## REMARKS

### I. Drawing Corrections

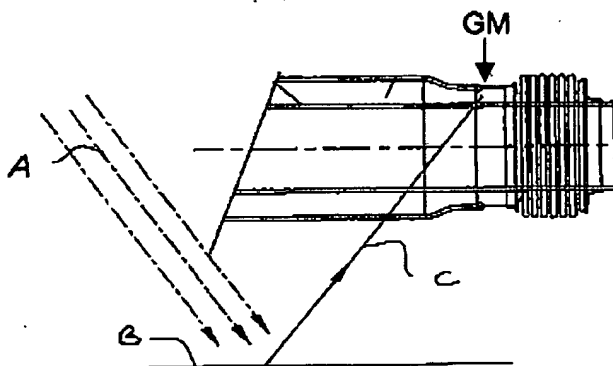
The drawing was objected to under 37 C.F.R. 1.83 (a) for failing to show each and every feature of the claimed invention in the previous Office Action dated April 13, 2005. The "parabolic collector" was not illustrated in the original drawing figures.

A figure 4 was filed with the amendment dated June 17, 2005 to correct this deficiency, but this new figure was not in compliance with 37 C.F.R. 1.121 (d) because it was not correctly labeled. Another copy of this new figure correctly labeled "new sheet" in accord with 37 C.F.R. 1.121 (d) accompanies and/or is attached to this amendment. The figure captions in the specification have already been appropriately amended.

This new figure 4 correctly shows the parabolic collector according to the invention including the absorber pipe according to the invention as described in the specification. Thus the new figure 4 should overcome the previous objection to the drawing.

For the foregoing reasons, withdrawal of the objection to the form of the replacement drawing sheet with the new figure 4 under 37 C.F.R. 1.121 (d) is respectfully requested.
